**Re: Response to NGI 1/4/17 Report
Independent Hydrogeologic Study
100 Long Ridge Road, Carlisle, MA**

The objective of this letter report is to comment on selected aspects of the NGI report dated January 4, 2017, "Additional Solute Modeling, 100 Long Ridge Road, Carlisle, Massachusetts" (Brem 336 01-04-17). An additional objective is to perform additional dispersion analyses to the northeastward from proposed Septic Disposal Area 3 (SDA3). The ZBA has requested these analyses because a potential sensitive receptor (well at 55 Suffolk Lane Extension) is located northeast of SDA3, and the proposed project has changed substantially since Nobis performed dispersion analyses in this area in 2015 (Nobis Phase 2 report dated May 1, 2015).

File: J:\89220\00 - Carlisle Hydrogeological Evaluation 2016\08\25\figural\figs 1 Carlisle_AOI_2017.01.mxd Date Printed: 1/11/2017

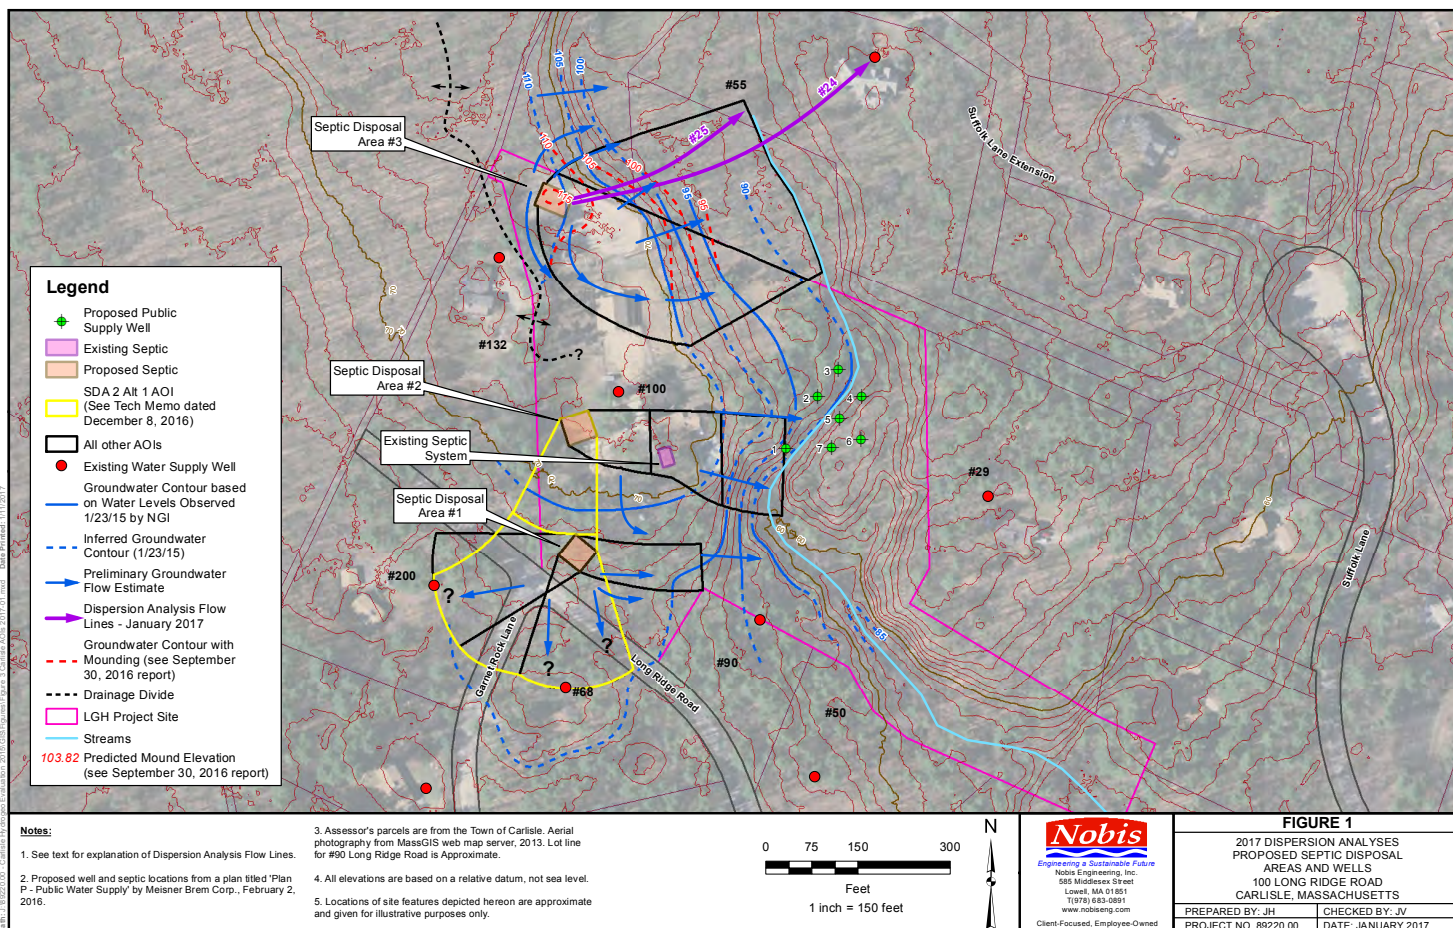
At the ZBA's request, Nobis conducted two dispersion analyses using the Domenico method. The analyses were along flow lines extending northeastward from SDA3 (Figure 1). Flow line 24 extends northeastward from SDA3 to the well that serves 55 Suffolk Lane Extension; flow line 25 is shorter and terminates in a gentle topographic low associated with a wetland at the headwaters of a brook that flows southeastward into the Site. (Flow line numbering is sequential, following previous flow lines numbered by Nobis and NGI and used for previous dispersion analyses. The new analyses were requested because previous dispersion analyses in this area were performed according to the 2015 plan which proposed to place SDA2 and SDA3 adjacent to each other.

The results of both analyses are less than 1.0 mg/L of nitrate, somewhat less than the result for flow line 11 (Table 5 in Nobis' May 1, 2015 Report) and near probable background levels for overburden groundwater. See Attachment 3 for details regarding the method, assumptions, input parameters, and results.

Of the two new analyses, the result for flow line 25 is probably the more realistic result, because this line ends in a topographic low, and the well at 55 Suffolk Lane Extension (end of line 24) is topographically higher than the end of line 25 (although the end of line 24 is lower than SDA3). It is more likely that overburden groundwater flow that includes effluent from SDA3 would discharge into the wetland/brook at the end of line 25 than that it would continue to flow northeastward.

However, these details regarding groundwater flow directions cannot be determined for sure without taking water level measurements in a series of monitoring wells in the area.

In conclusion, it is unlikely that the well at 55 Suffolk Lane Extension would be impacted by SDA3 unless a bedrock fracture that is hydraulically connected to the well reaches the top surface of the overburden, closer to SDA3 and in an area where the clay layer and dense glacial till noted in a boring at the SDA3 location are not present.

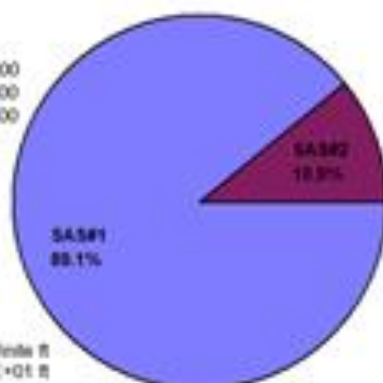
2. Nobis had used an effective porosity of 0.2 and a total porosity of 0.35. The "porosity" listed in the tables in the NGI Report appears to correspond with the total porosity value. The SEVIEW program uses effective porosity for its program input. However, the input parameters listed in Appendix B include a value of 0.35 for effective porosity.

c. If 0.35 was indeed used for effective porosity, can you re-run the program to determine the difference (if any) between using 0.2 and 0.35 for the ultimate output?

I re-ran AT123D with a porosity of 0.20 and the result is attached. Using an offset for the well at #68... (i.e. not a centerline calculation) I get 4.46 mg/l with $n_e = 0.20$ versus 3.91 mg/l from the original model run with $n_e = 0.35$.

I attached a screen shot of the aquifer input parameters for AT123D.
